Remarks:

Reconsideration of the application is requested.

Applic. No. : 09/363,277

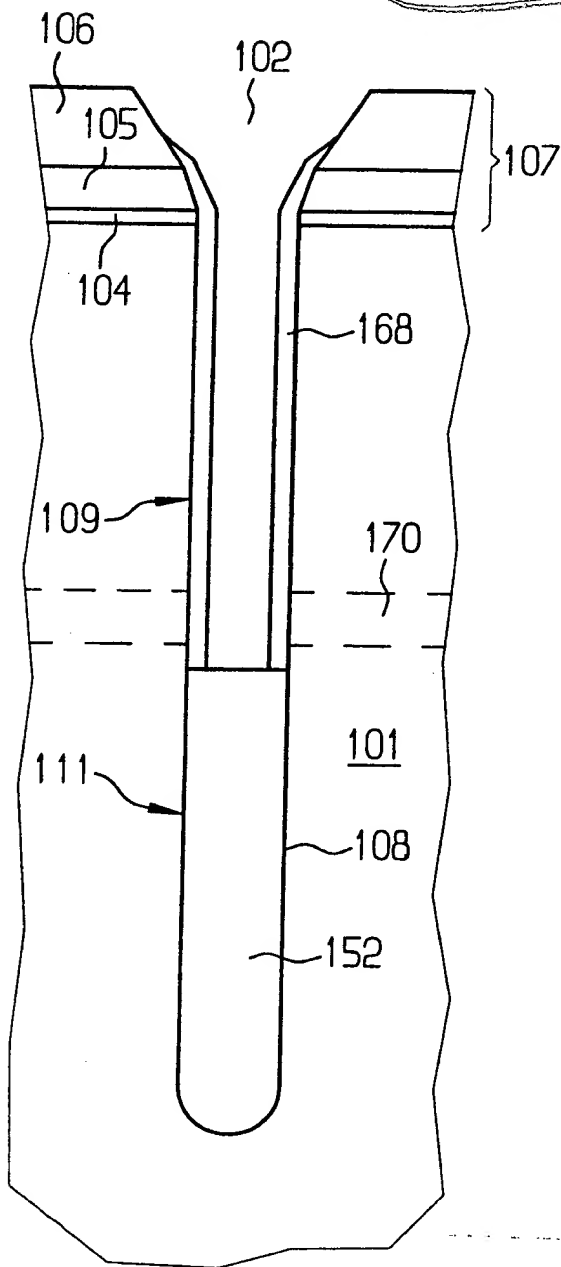
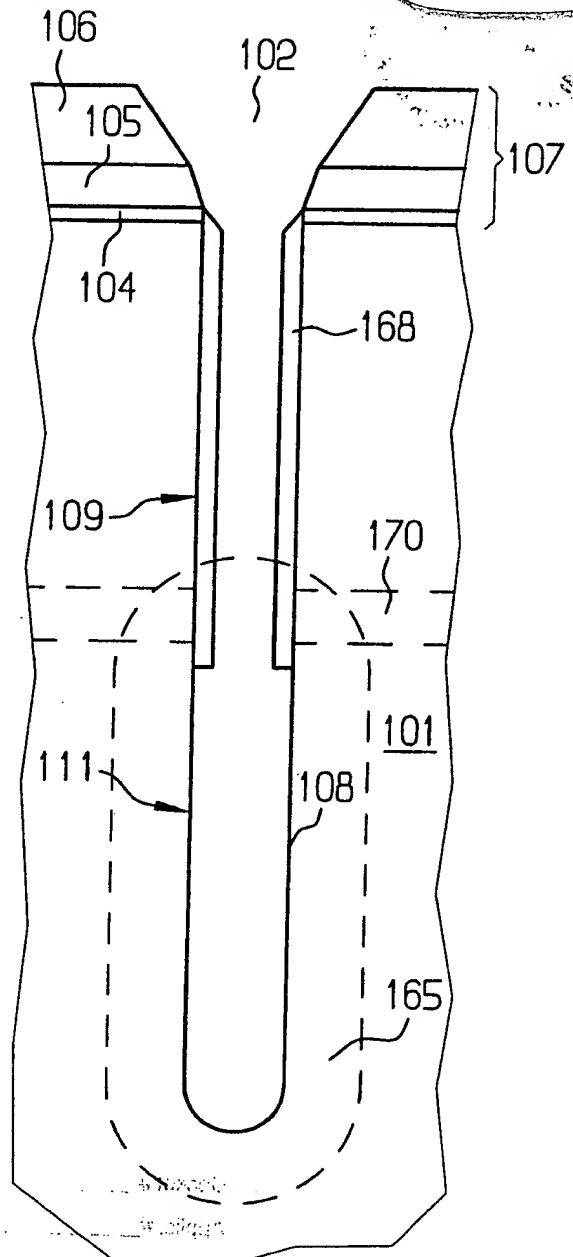
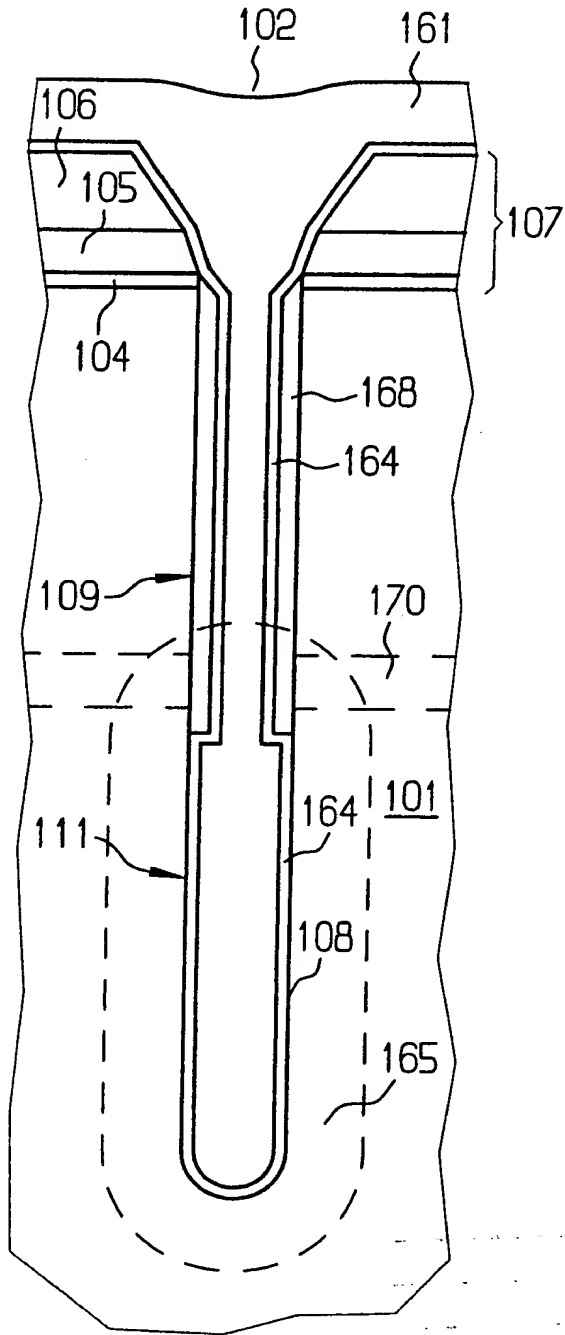
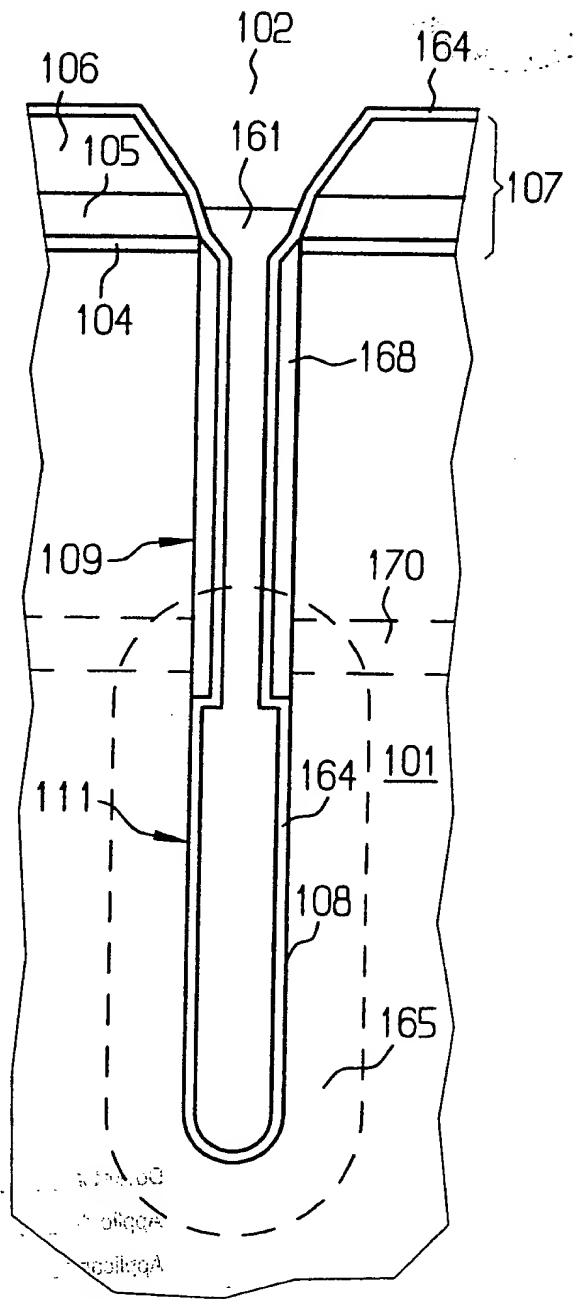
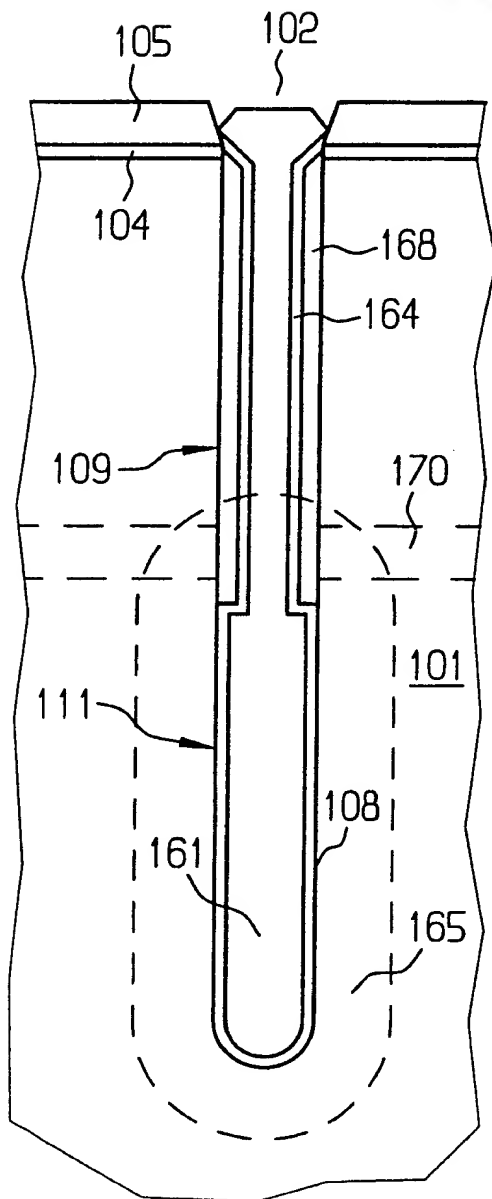
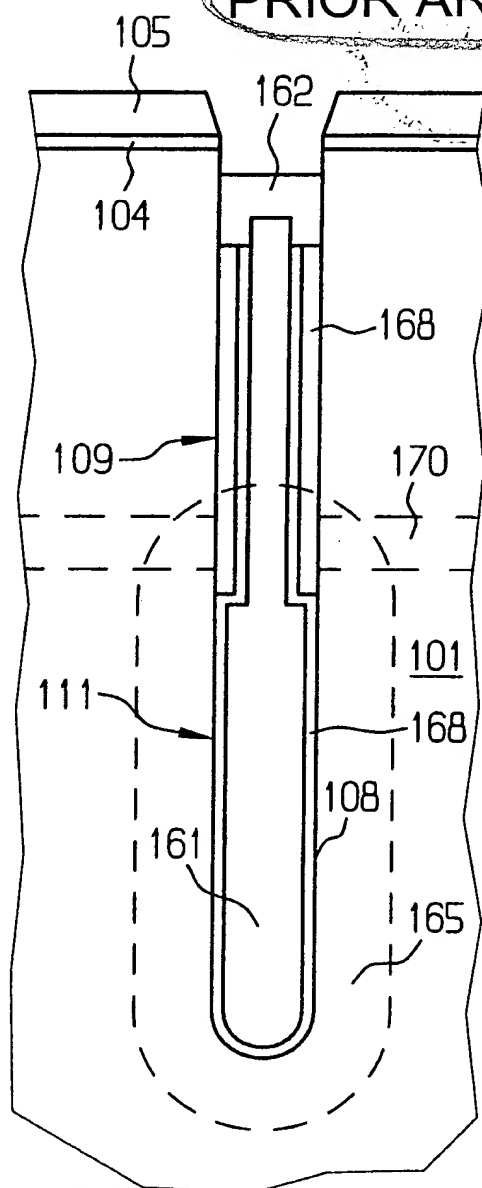
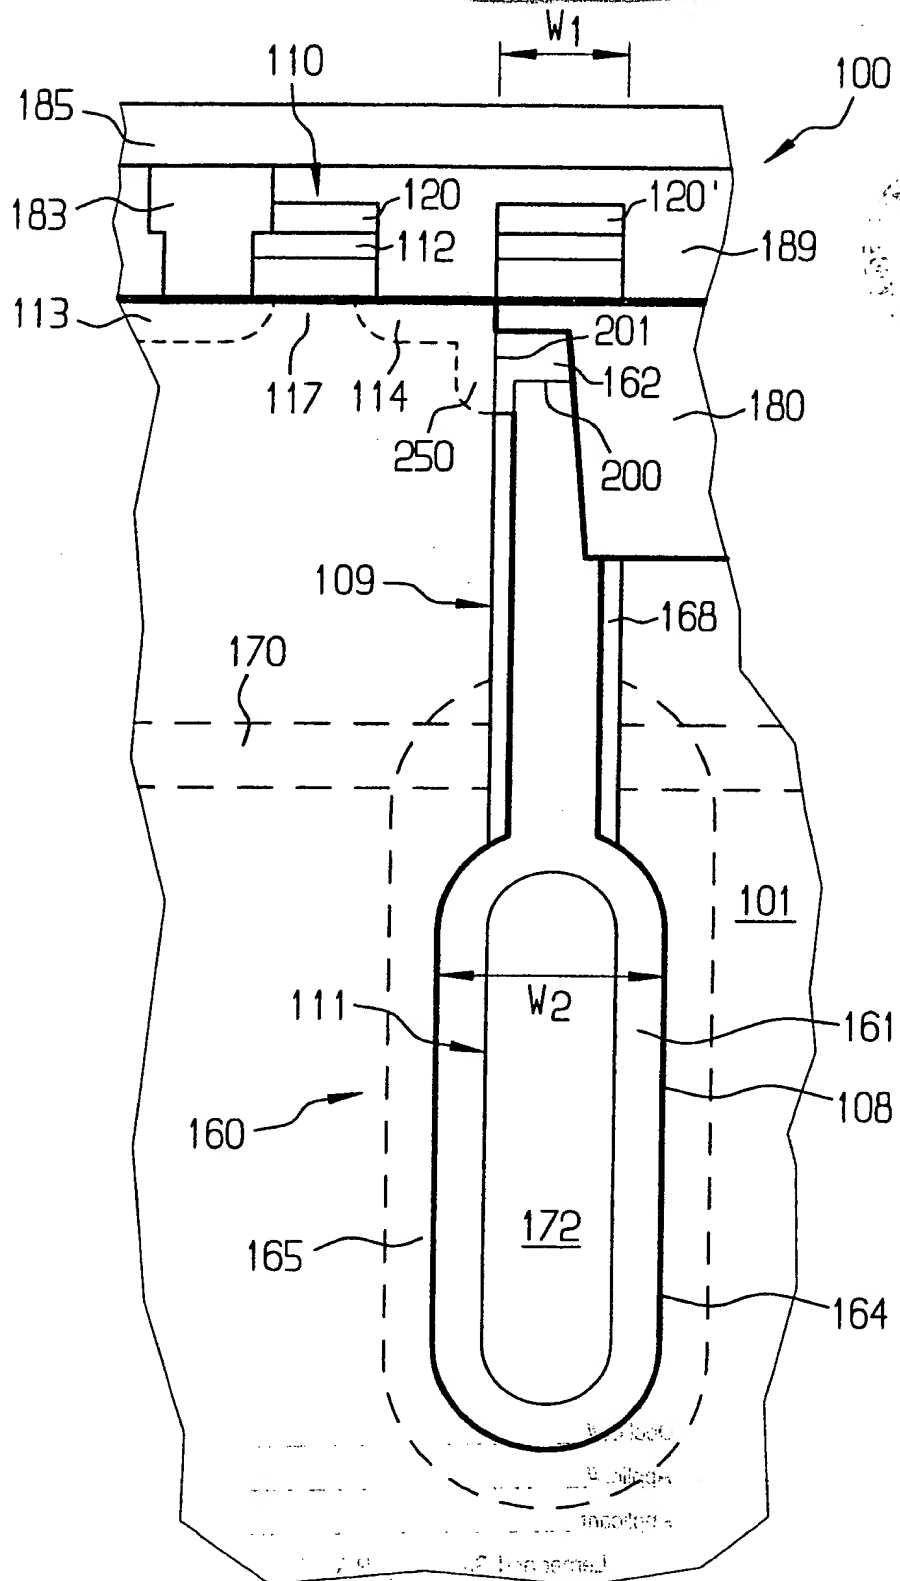
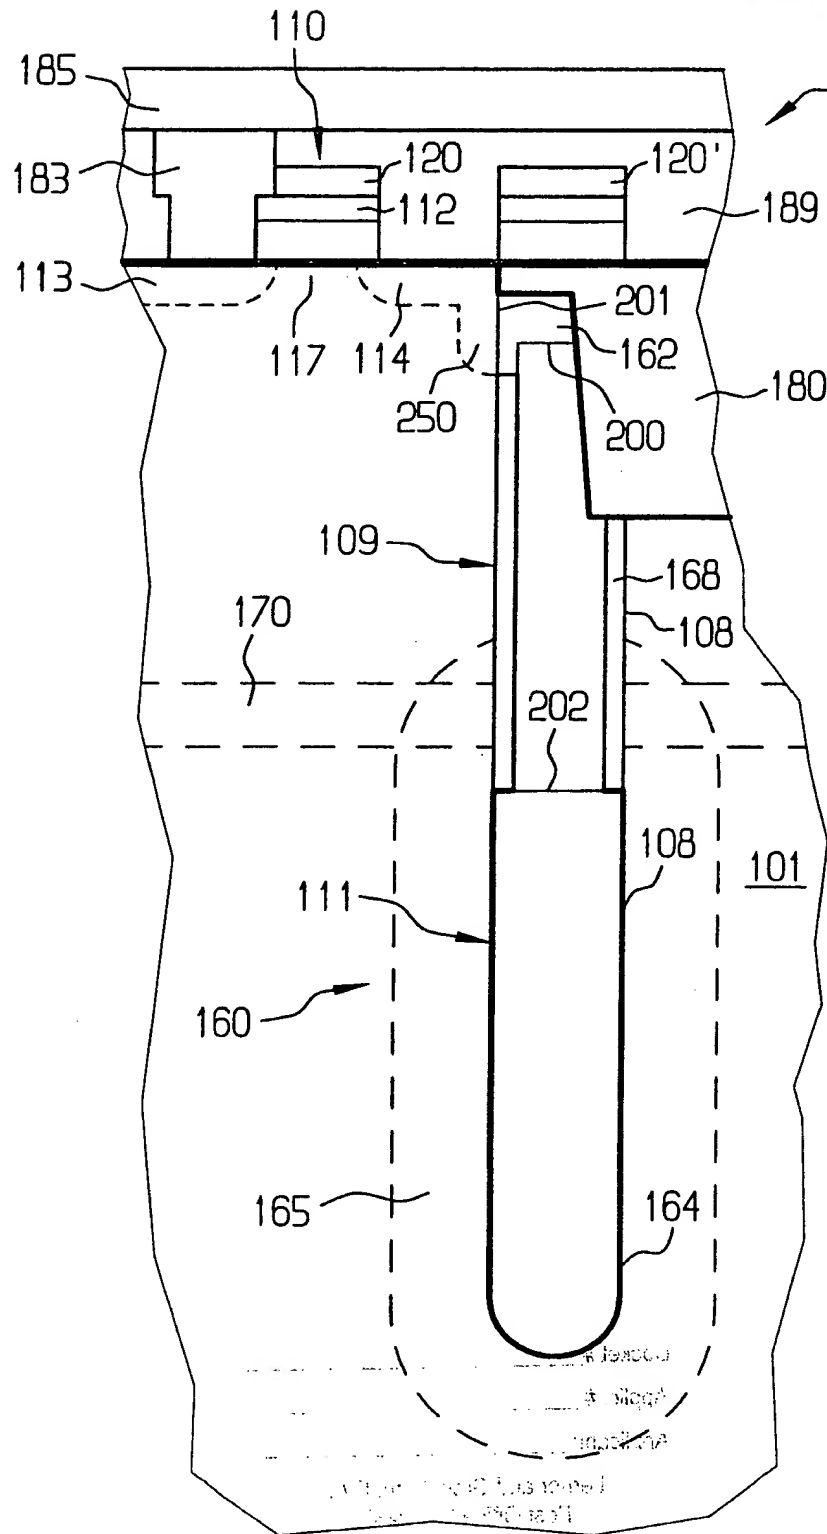
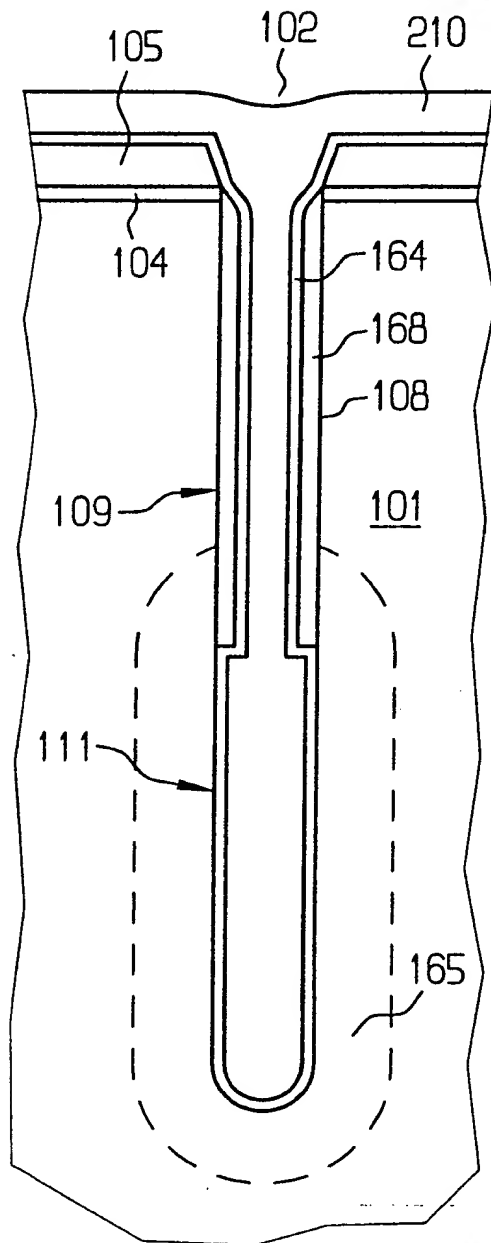
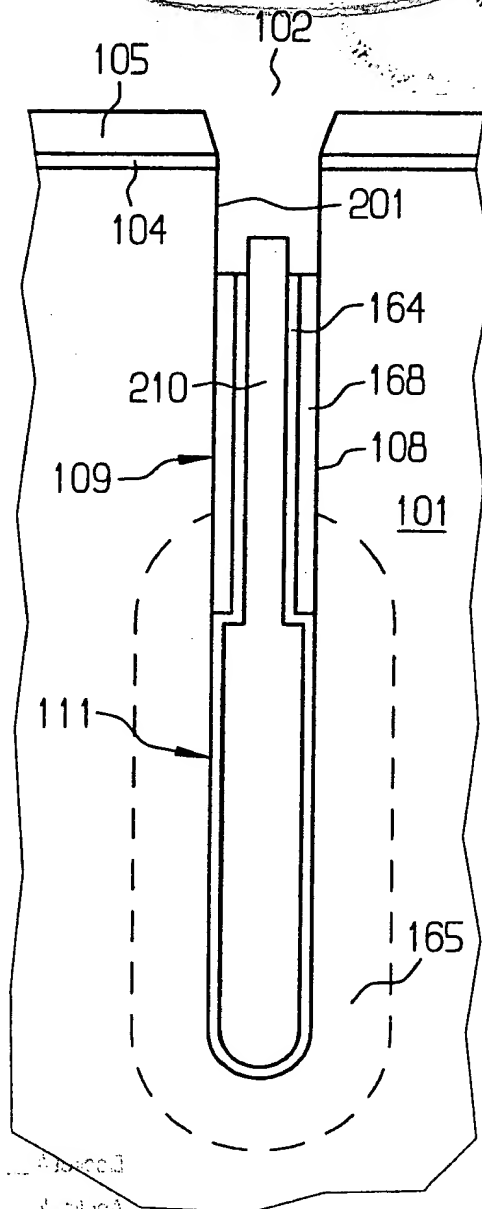
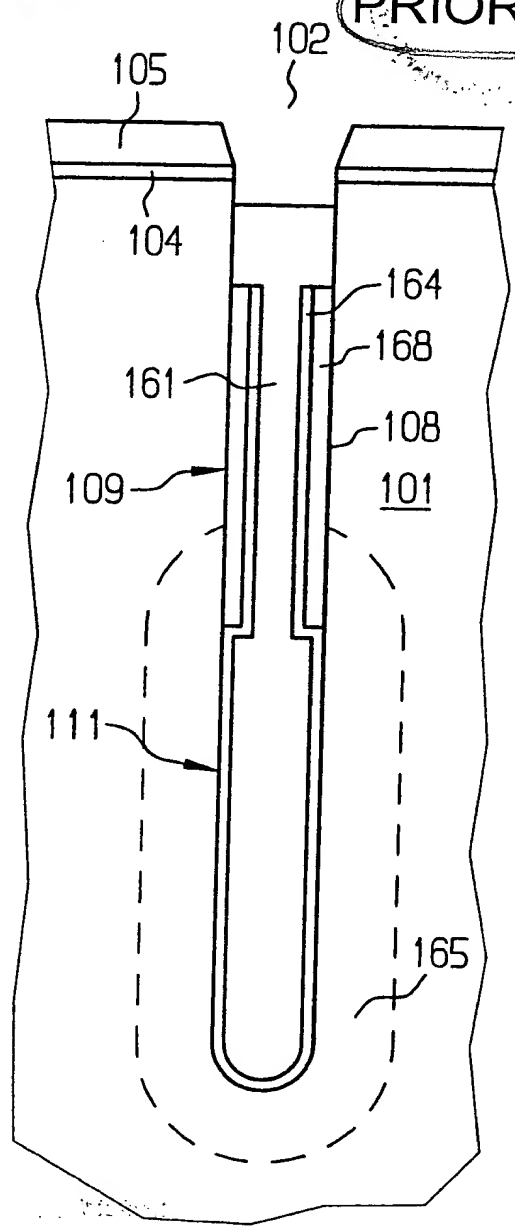
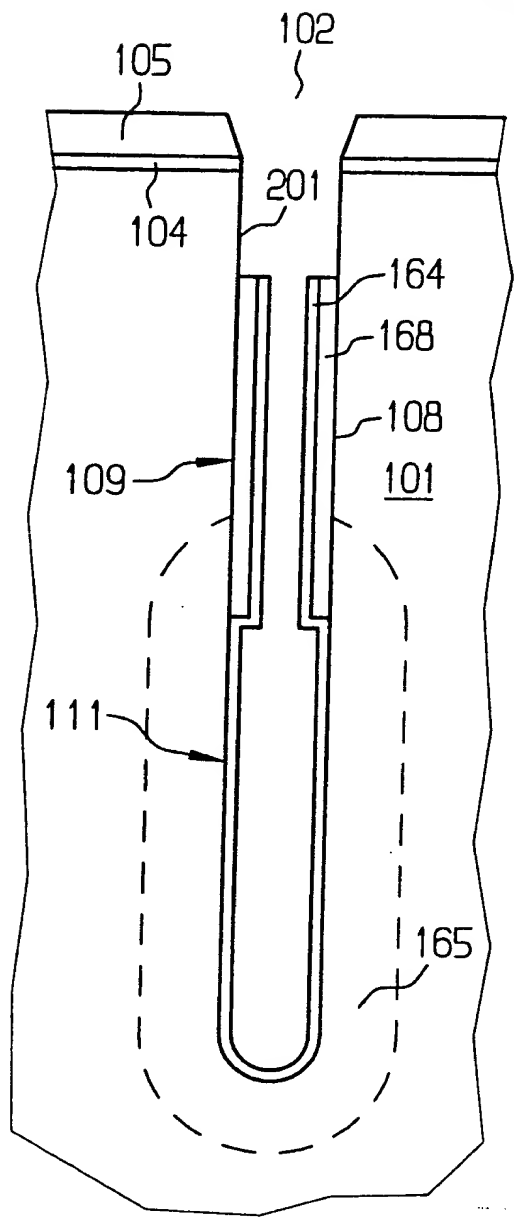
In the second paragraph on page 3 of the Office action, Figs. 6-12 of the drawings were objected to as not containing a legend such as --Prior Art--. Figs. 6-12 of the drawings were corrected as suggested by the Examiner. New "final" drawings of Figs. 6-12 are enclosed.
